ROCHESTER GAS AND HEATING CORPORATION • 19 EAST AVENUE, ROCHESTER, N.Y. 14610

February 1, 1982

Subject: SEP Topics VI-2.D and VI-3  
R. E. Ginna Nuclear Power Plant  
Docket No. 50-244

### COMMENTS ON NRC SAFETY EVALUATION

FIGURE 2  
CONTAINMENT PRESSURE  
STEAM BREAK HZP  
1/2 SPRAY SYSTEM

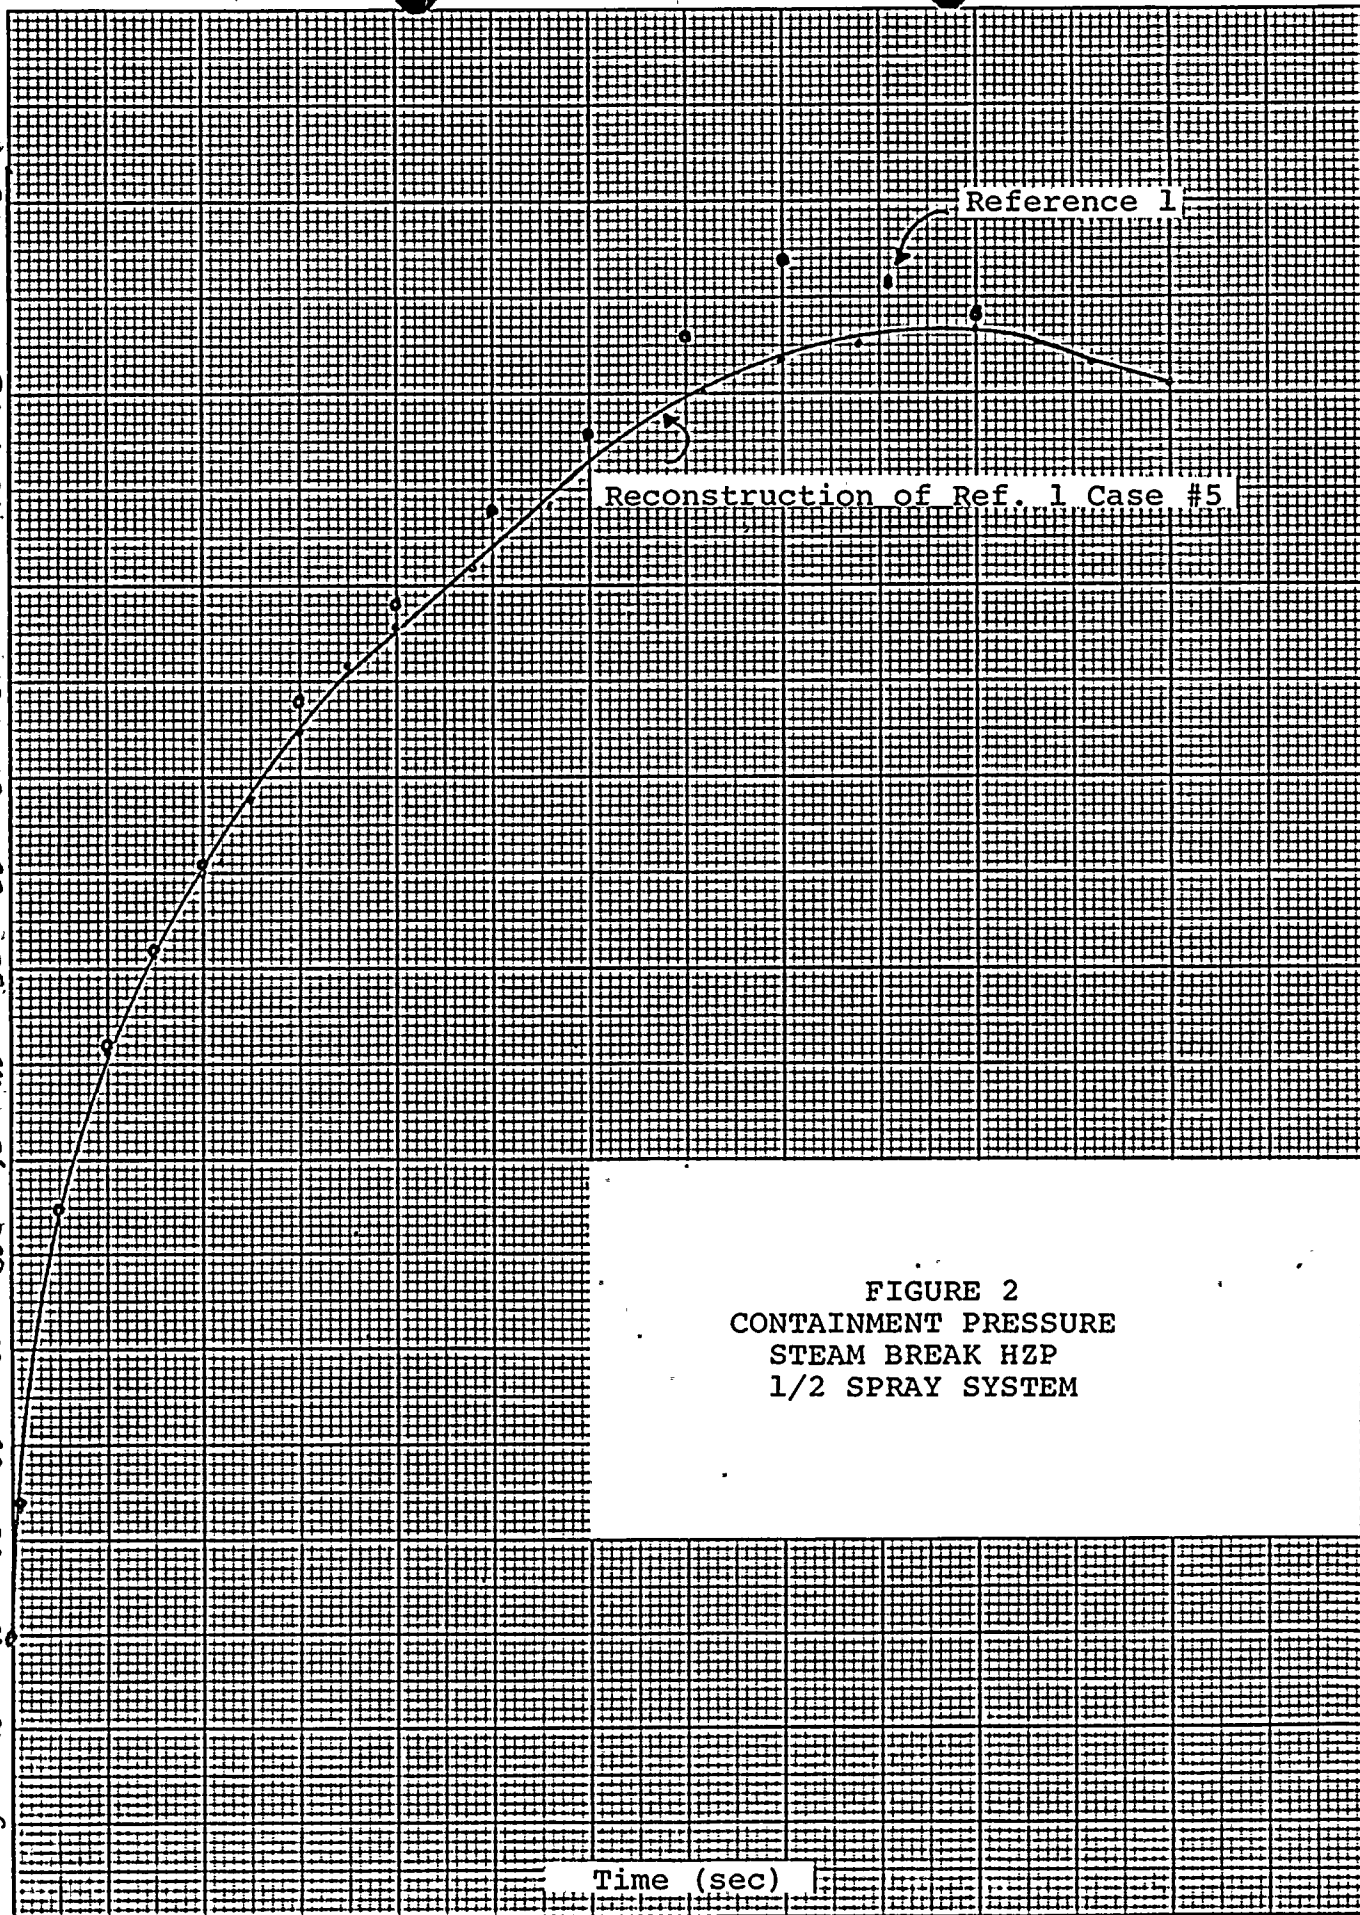
The highest containment pressure was calculated in Reference 1 to occur for a large steam line break at HZP with failure of one spray train. The input for this case was run using CONTEMPT-EI/28B. Figure 1 and 2 illustrates the results of this run and points taken from Reference 1. The following peak temperature and pressure was obtained.

FIGURE 4  
CONTAINMENT TEMPERATURE  
STEAM BREAK HZP  
1/2 SPRAY SYSTEM

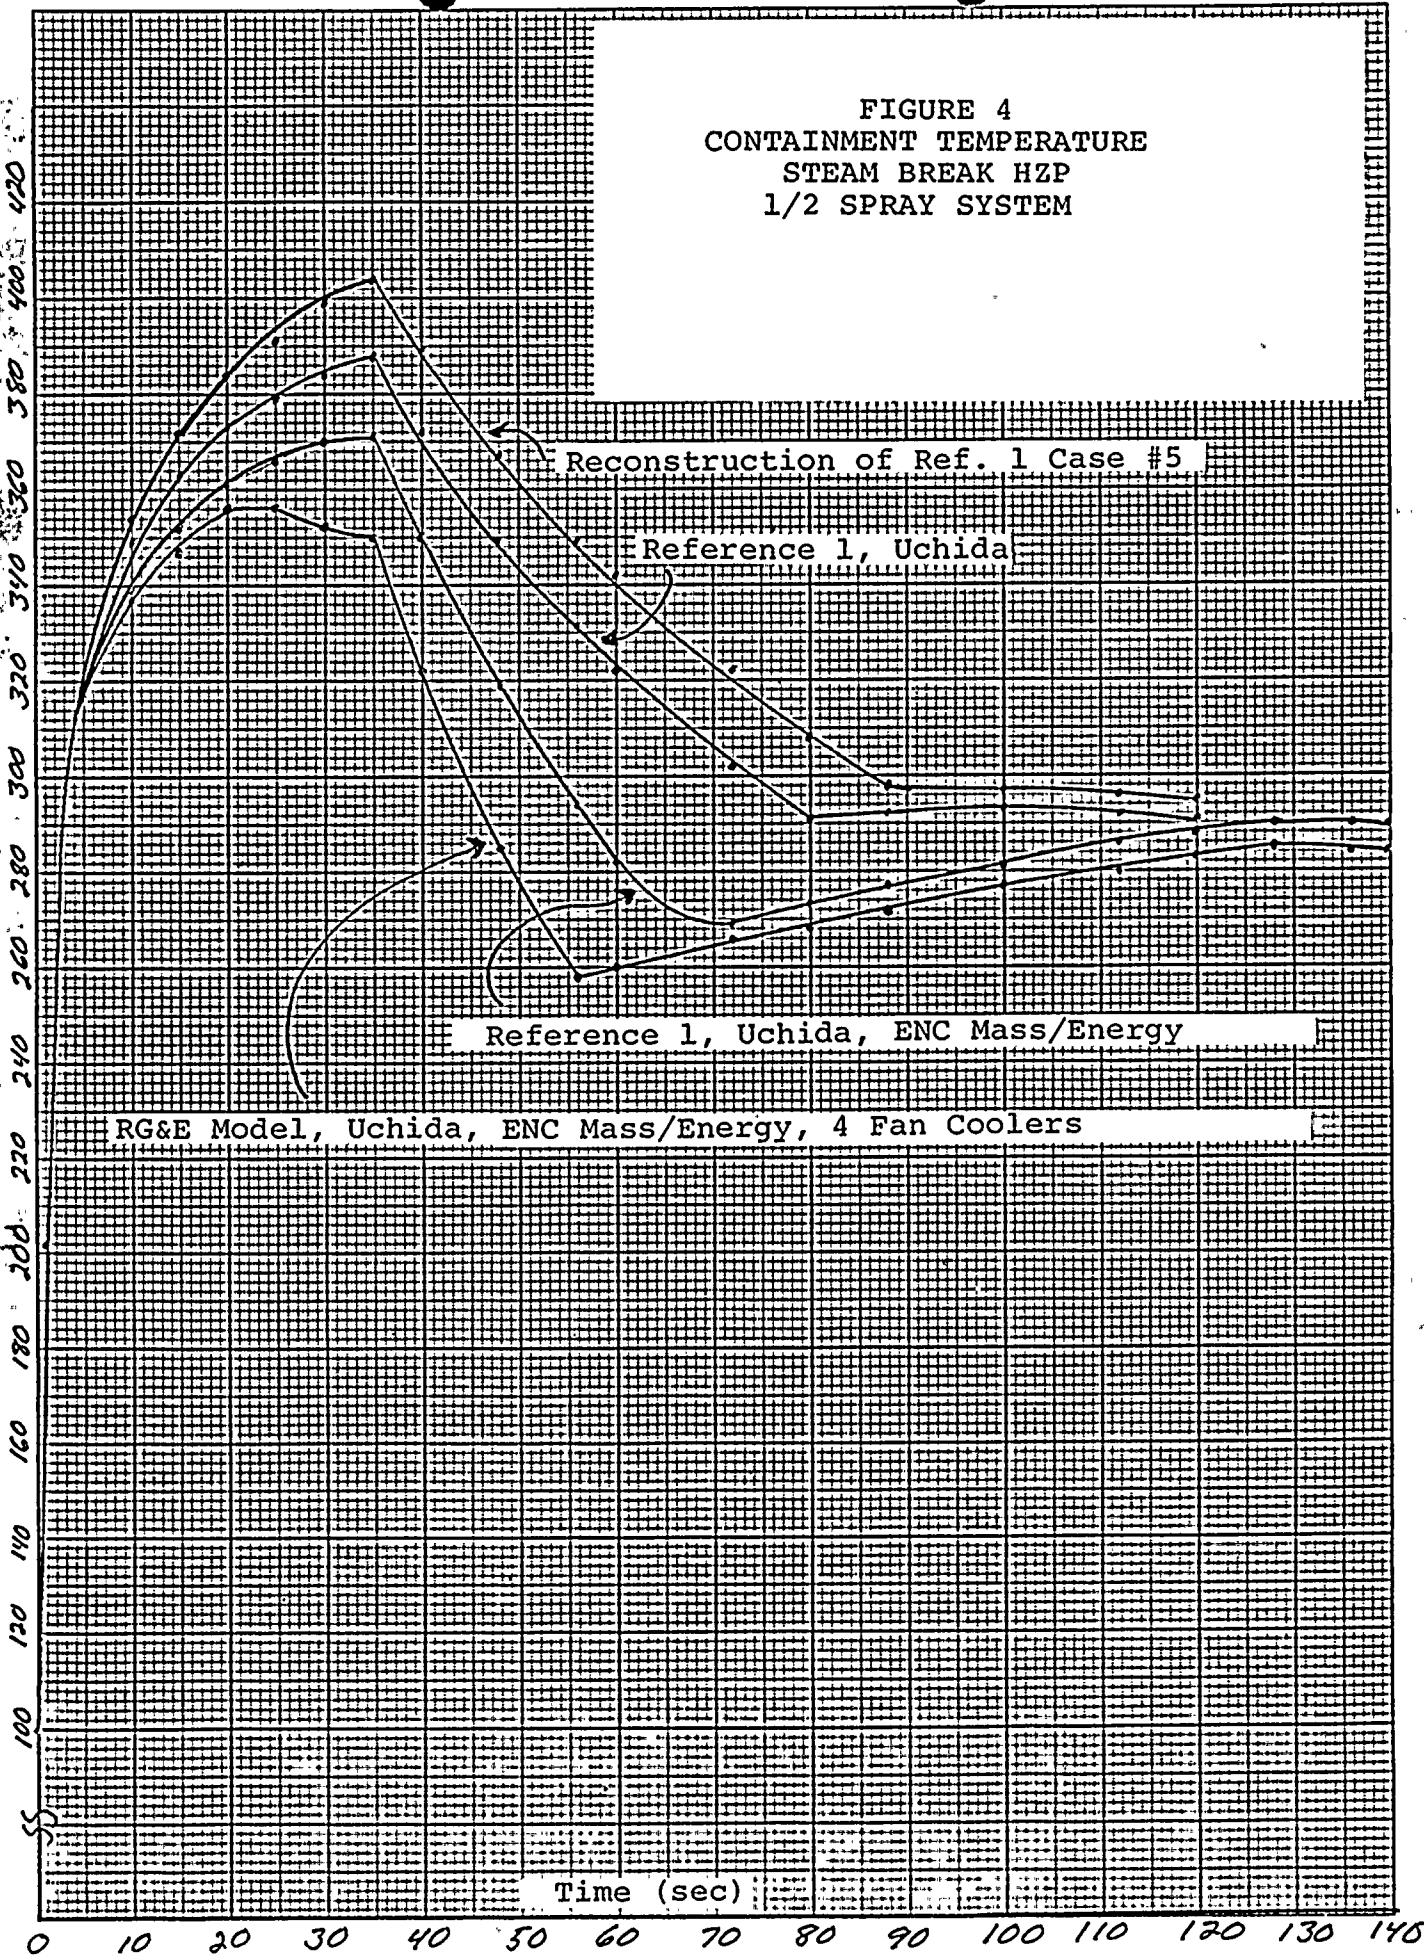
Figures 4 and 5 illustrate the effect of Uchida, ENC mass and energy, and the RG&E containment heat sink model on the worst case containment response presented in Reference 1 (#1, #4, #5, and #11 of Table 1).
